ADDENDUM

PROJECT TITLE: SAINT JOHN POLICE HEADQUARTERS LIGHTING RETROFIT	ADD. NO: 1
TENDER NO: 2023-082303T	DATE: June 14 th , 2023
PAGE 1 of 3 (Including Confirmation Sheet)

Project Name: MBDER PKG #A13C – City of Saint John Police Headquarters - Lighting Retrofit

SKE-01

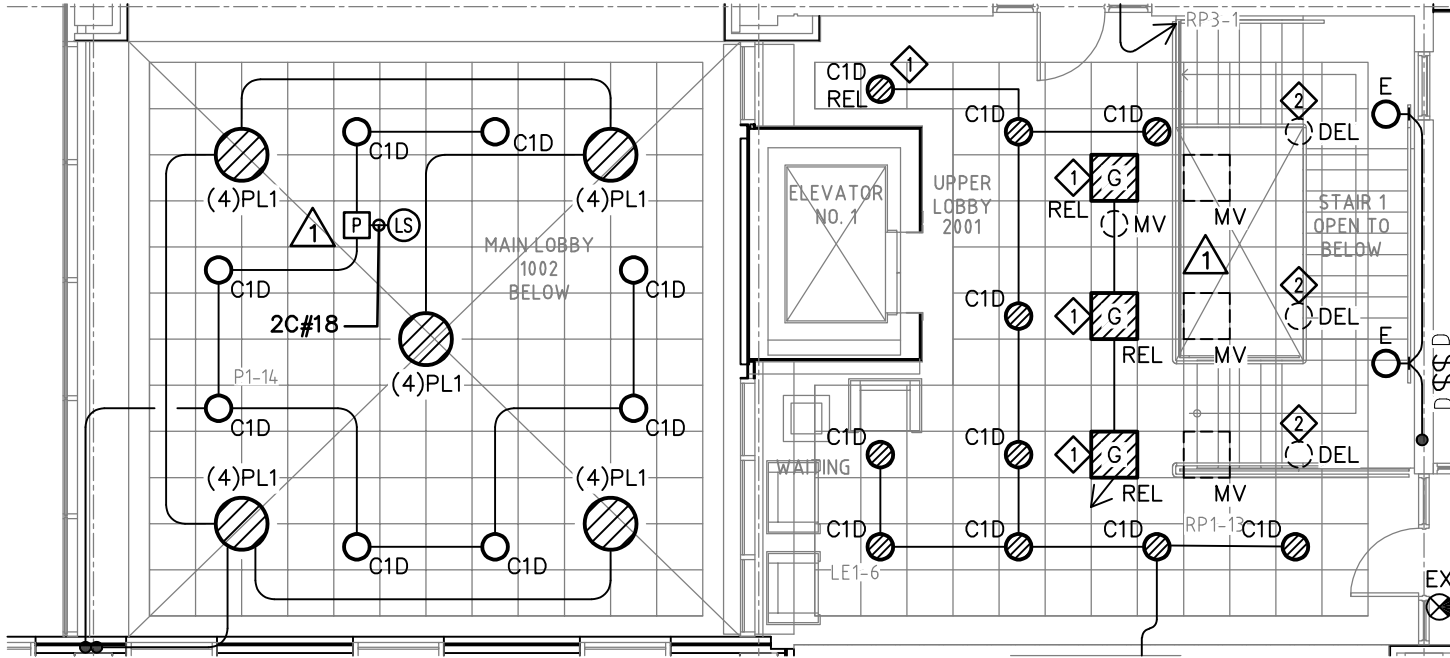
- ① NO LUMINAIRE IN THIS LOCATION PRESENTLY. EXTEND EXISTING CIRCUIT AS REQUIRED.
- ② PROVIDE CEILING TILE TO MATCH EXISTING.
